Comment Letter RD800

Responses to Comments

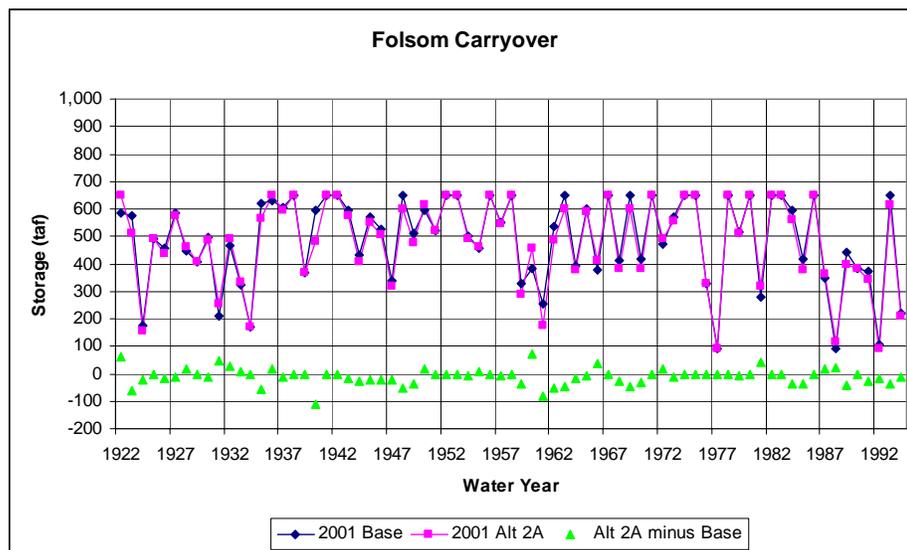
The SDIP EIS/EIR states that SDIP would reduce average carryover storage at Folsom Reservoir by an average of 22 taf because of the increased deliveries from the Reservoir to satisfy the increased export demands. It is not the average that primarily concerns the District, but rather the intermittent years in which Folsom storage could be reduced significantly. In those years when reduced Folsom carry over storage spikes significantly lower, water contractors south of the Delta should receive water provided from other reservoirs within the system. As the SWP and CVP continue to evaluate the operational criteria to utilize the additional capacity made available by the SDIP, it is imperative that any potential impact to the reliability of surface water deliveries to Sacramento-area CVP contractors be analyzed and mitigated in a suitable manner.

Folsom Reservoir operations will not be changed by the SDIP Stage 2 alternatives. Reclamation operates Folsom to meet all local water contracts and supply all water rights. The Water Forum agreements are included in the CALSIM modeling. The description in Section 5.1 of a reduction in Folsom Reservoir carryover of 22 taf refers to the expected changes under 2020 baseline conditions, largely because of the higher water supply deliveries from Folsom. The SDIP has no additional effects on Folsom Reservoir levels.

The monthly CALSIM results for the SDIP 2001 and 2020 baselines and each alternative can be reviewed in a single Excel spreadsheet (MacroSets_RussOutputs_10-18-05.xls) from the SDIP website (<ftp://ftp.modeling.water.ca.gov/pub/SDIP/DSM2_SDIP_results>).

For example, Alternative 2A will reduce the average carryover storage by less than 10 taf. The pattern of carryover storage will not be substantially reduced. The figure below illustrates these small simulated changes.
